737

Service Bulletin

Number: 737-24-1214
Original Issue: May 12, 2015
ATA System: 2421

SUBJECT: ELECTRICAL POWER - AC Generation System - Power Feeder Wire Bundle Support Installation

**FIGURE 1: WIRE BUNDLE W4722 WIRE SUPPORT STRINGER CLIP ASSEMBLIES INSTALLATION
(SHEET 1 OF 5)**

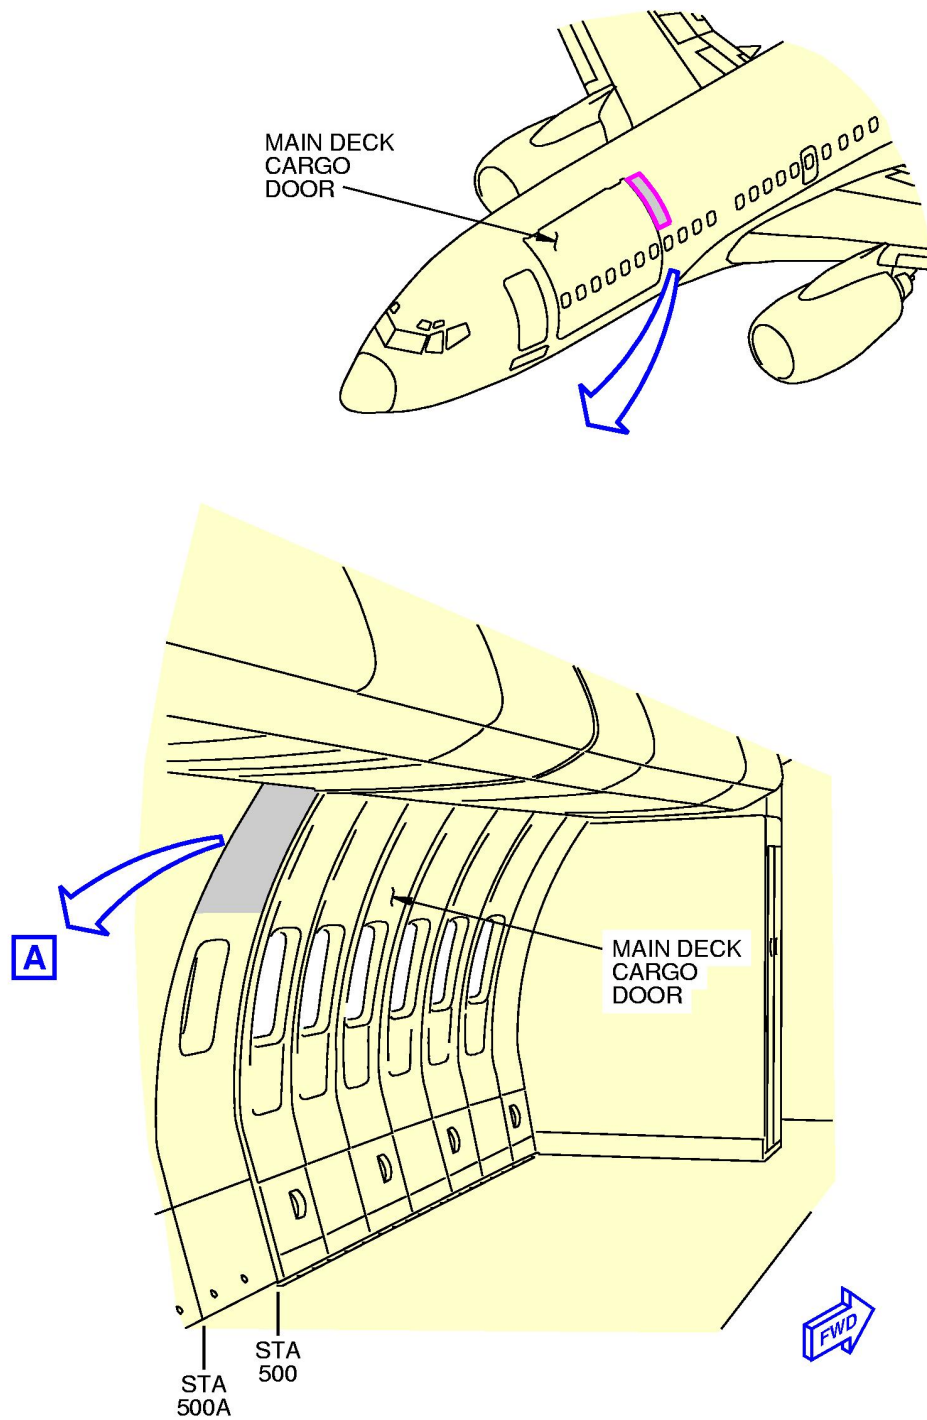
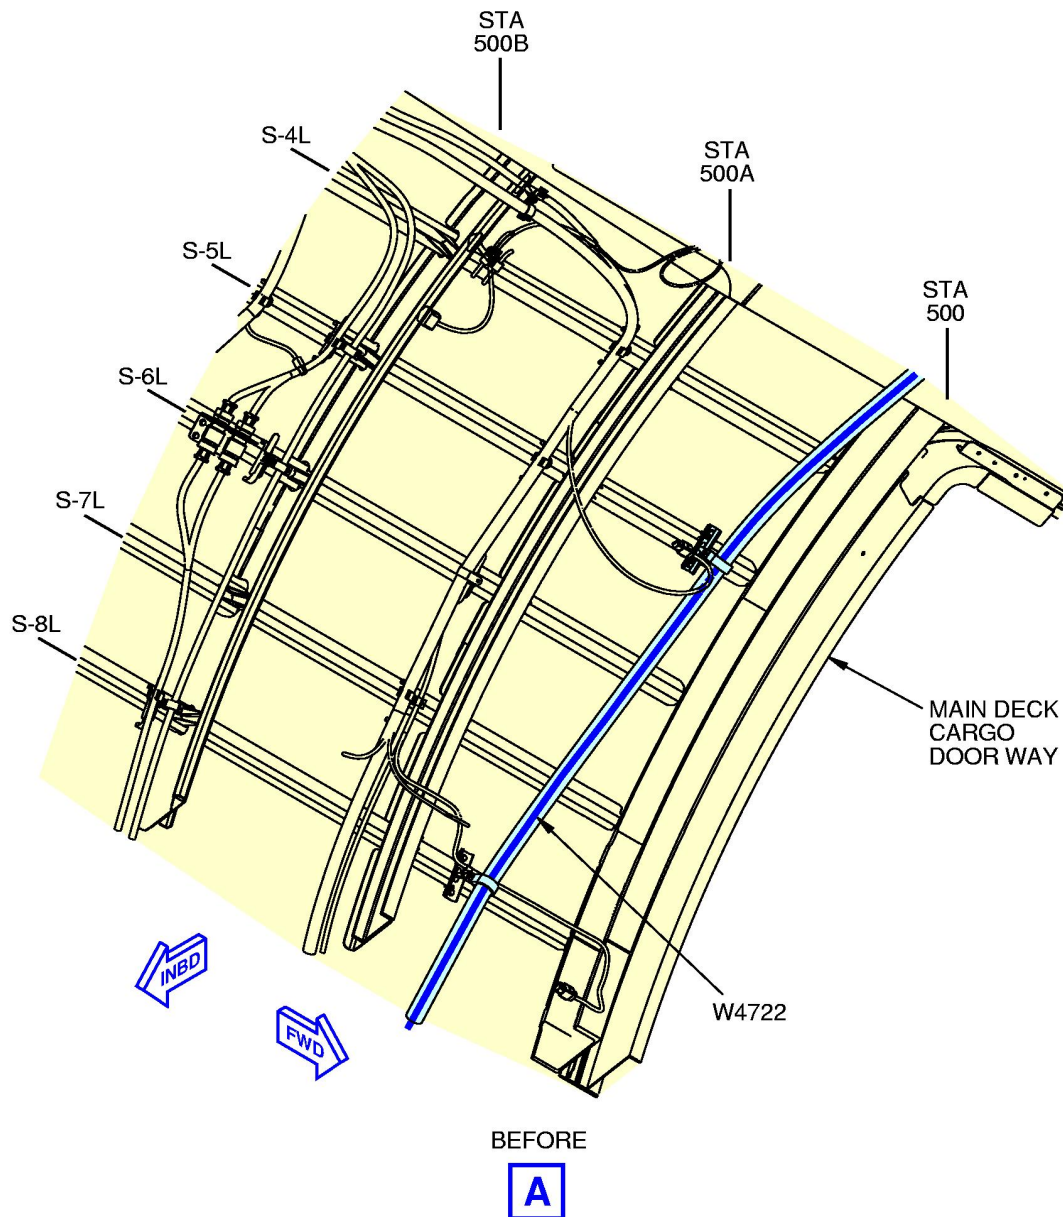
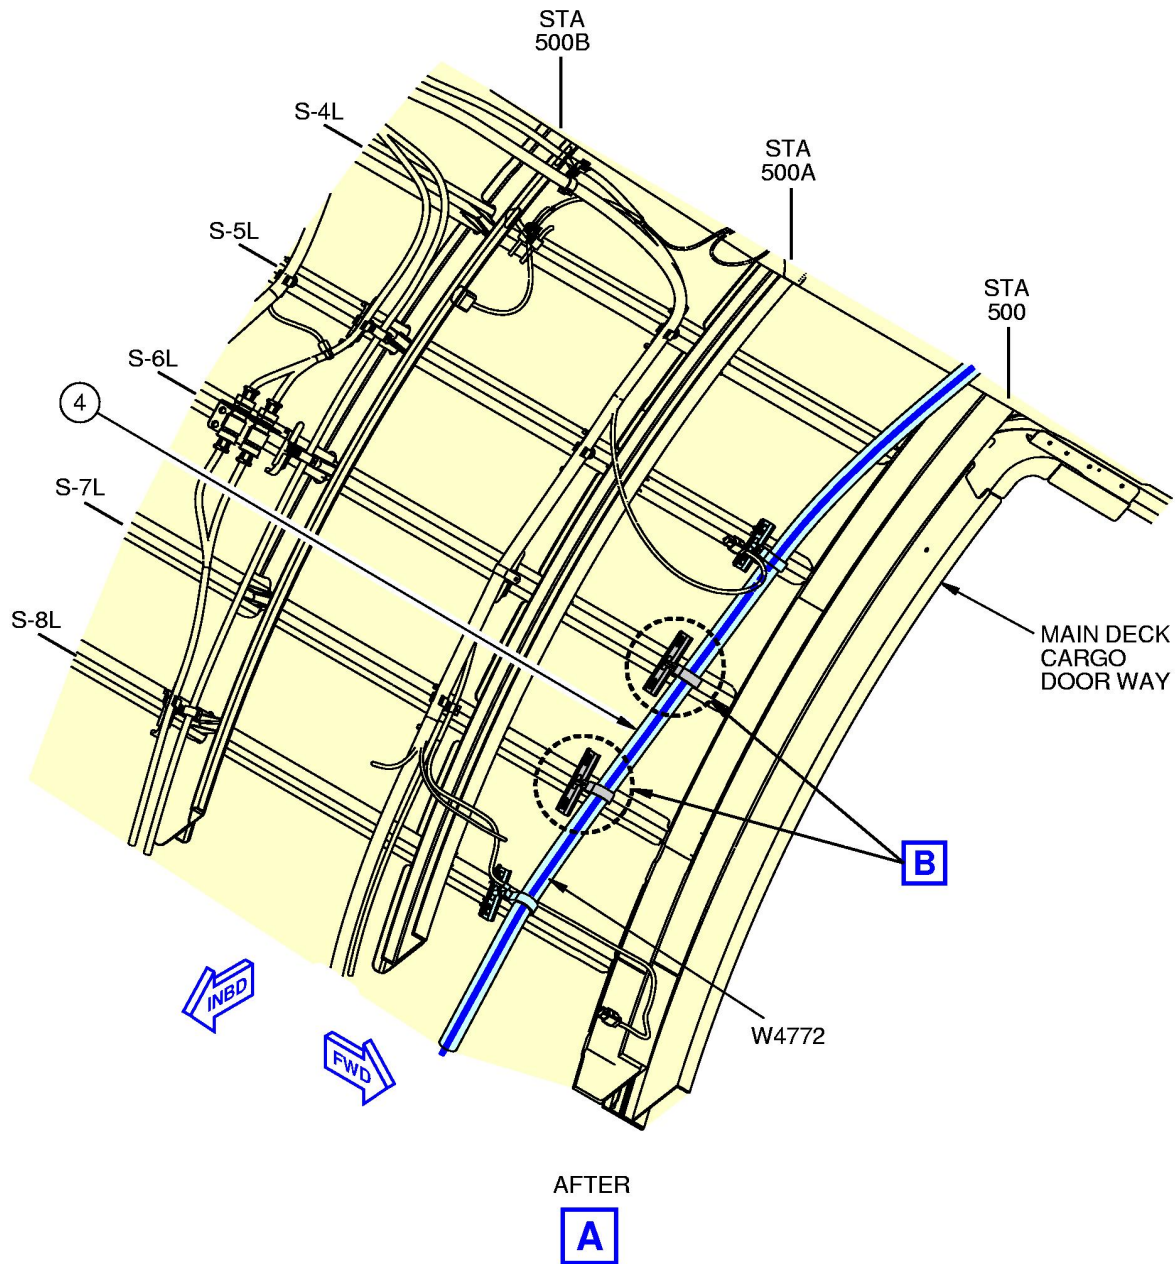
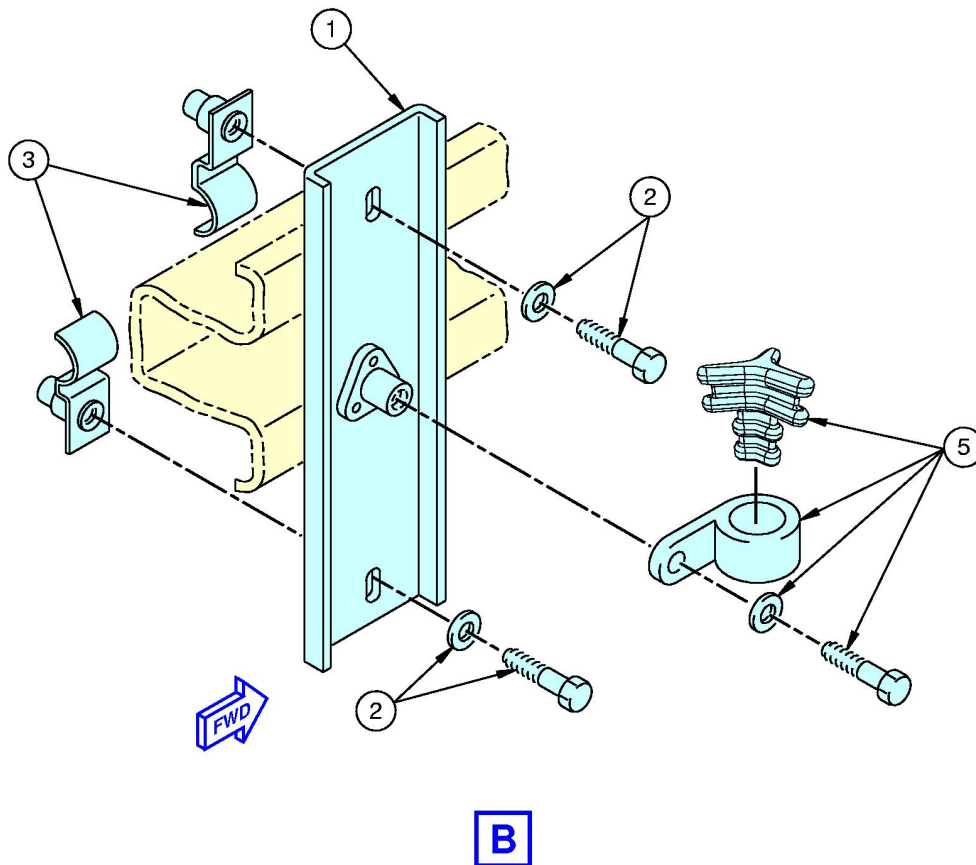
This service bulletin provides instructions on installing two additional wire support stringer clip assemblies for wire bundle W4722 located in main deck cargo area between stations 500 and 500A. It will prevent for wire bundle from rubbing on the overhead stowage bin sidewall. If this service bulletin is not accomplished, it may lead to wire bundle damage resulting in potential loss of Auxiliary Power Unit (APU) power channel.

Boeing evaluated during production that wire bundle W4722 is not properly secured against the overhead stowage bin sidewall. Upon further investigation, Boeing has decided to install two additional wire support stringer clip assemblies.

Get access to wire bundle W4722 located next to main deck cargo door between stations 500 and 500A. Install wire support stringer clip assemblies at locations S-6L and S-7L. Close access.

4. Install the wire support stringer clip assemblies in accordance with FIGURE 1.
5. Install the kept sidewall panel on left side of the airplane. Refer to 737-600/700/800/900 AMM 25-21-46 as an accepted procedure.

Step	Task	Name	Identification	Qty	More Data
1	Install (New)	METAL STRINGER CLIP, WIRING SUPPORT	287A4011-47	2	
2	Install (New)	SCREW	BACS12GU3K10	4	(a)
	Install (New)	WASHER	NAS1149D0332J	4	
3	Install (New)	STRINGER CLIP ASSEMBLY	69-37170-1	4	
4	Route	WIRE BUNDLE	W4722	1	
5	Install (New)	SPACER-WIRE SEPARATOR	287N1115-1	2	(b)
	Install (New)	WIRE BUNDLE CLAMP	TA027016-17	2	
	Install (New)	SCREW	BACS12GU3K10	2	(a)
	Install (New)	WASHER	NAS1149D0332J	2	
(a) Refer to 737-600/700/800/900 AMM 20-50-11 for Torque Values.					
(b) Refer to SWPM 20-10-20 as an accepted procedure for wire preparation and spacer installation.
